# ***Interactive comment on “Assessing the hydrologic restoration of an urbanized area via integrated distributed hydrological model” by D. H. Trinh and T. F. M. Chui***

**D. H. Trinh and T. F. M. Chui**

Received and published: 28 July 2013

**Fig. 1.** Groundwater depth, infiltration rate and groundwater recharge across bio-retention systems with different soil hydraulic conductivity. Results are from 12 hours after largest rainfall event (130mm)

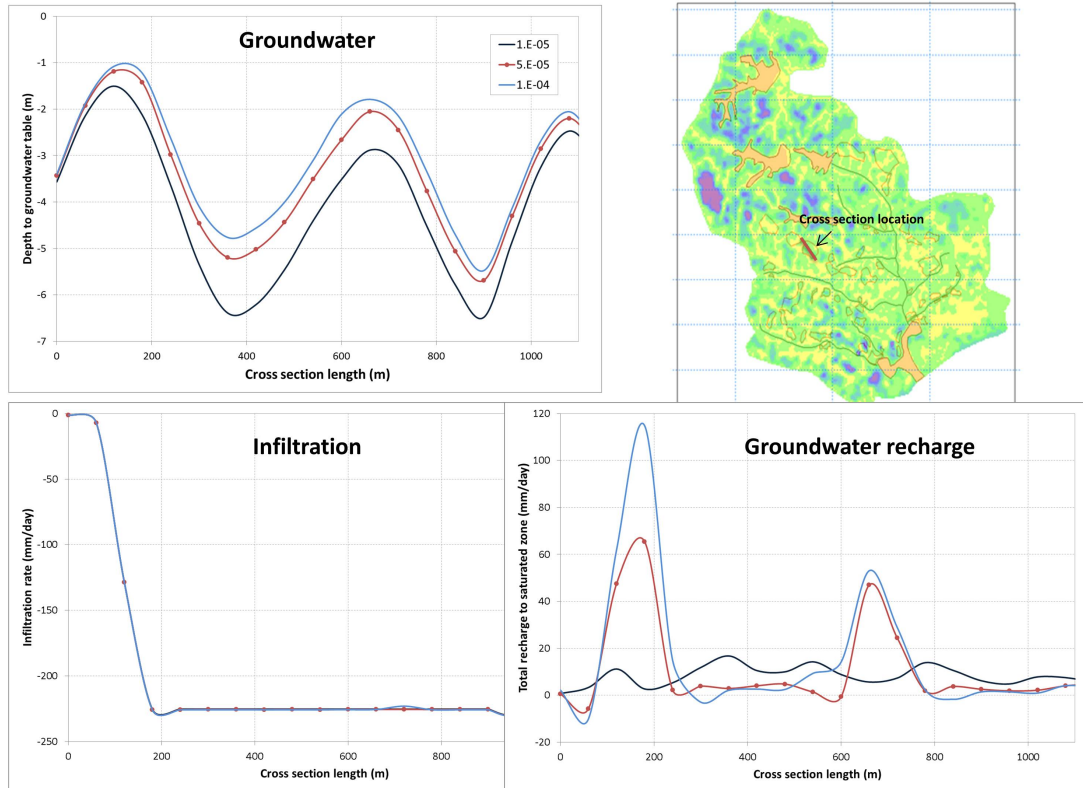
- Page 4108, line 23: the hydraulic conductivity of the soil is very similar to that of soil in bio-retention systems; I would have expected bio-retention systems to have larger hydraulic conductivity, of the order of 150-200 mm per hour (instead of about 40 mm per hour as used by the Authors).

- Page 4115, lines 9-14: according to the chosen parameters, the hydraulic conductivity of bio-retention systems is similar to that of the surrounding soil. This allows water to percolate into the surrounding soil, without accumulating in the systems. I would consider to increase the soil hydraulic conductivity of bio-retention systems to see the effect of recharge.

- Secondly, in response to the referee's comment, we have also carried out two more simulations using bio-retention systems with soil hydraulic conductivity of  $5 \times 10^{-5}$  m/s (180 mm/hr) and  $10^{-4}$  m/s (360 mm/hr) which are higher than the original value of  $10^{-5}$

m/s (36 mm/hr). The results show that the difference in outlet discharge among the scenarios is insignificant. Taking a bio-retention system at the centre of the catchment as an example, Fig. 1 presents the groundwater table, infiltration rate and groundwater recharge across the system 12 hours after the largest rainfall event in the simulated year. This event has a rainfall depth of 130 mm and an intensity of 26 mm/hr. The infiltration rates of the different scenarios are the same, as the rainfall intensity is lower than all the soil hydraulic conductivity values. There is more recharge to the saturated zone at that particular moment leading to a higher groundwater table in the scenario with higher soil hydraulic conductivity. However, the total recharges of all scenarios reach the same values eventually. The temporal difference in groundwater recharge is because rain water requires different duration to travel through the unsaturated zone to reach the saturated zone depending on the soil hydraulic conductivity. Therefore, we believe the original soil hydraulic conductivity of bio-retention system is reasonable as increasing soil hydraulic conductivity does not affect the overall recharge amount. We will add the information above in the revised manuscript.

**Fig. 2.** Groundwater (GW) table depth and vegetation distribution Marina-like catchment

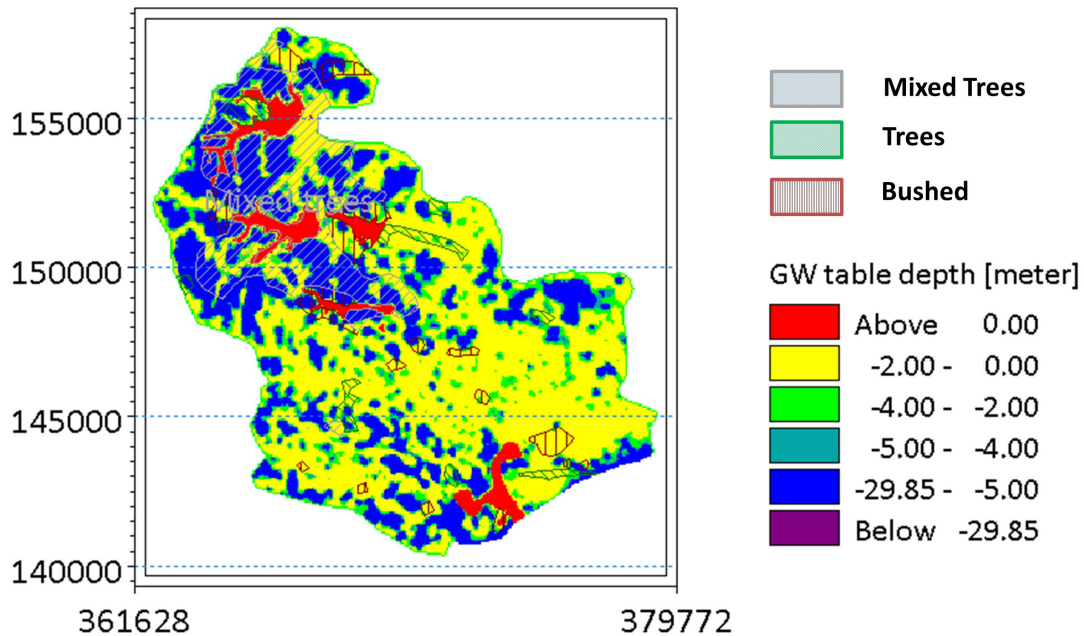
12. About the root depths of vegetation: Table 1: the root depths are well below the water table; this is unlikely, since many species would suffer under such conditions. The Authors should provide a reference to justify this choice.

[Response] According to Singapore National Parks Board (Npark), tree height in Singapore varies in the range from 4 meters to more than 20 meters (NPark, 2011). Based on the relationship between tree height and root depth from Štofko (2010), the root depth is approximately 3.5 meters for a 4.0 meter tree. In addition, a recent survey in Singapore shows that the root of vegetation can be more than 3 meters (Ngo et al., 2013). Thus, we believe that our assumption on root depth is reasonable. Furthermore, most of the vegetation with deep roots locates in the upstream of the catchment where the groundwater table is mostly below 5 meters (Fig 2). The rest, locating in the downstream area, either has shallower root or is wetland vegetation that is more resistant to flooding conditions.
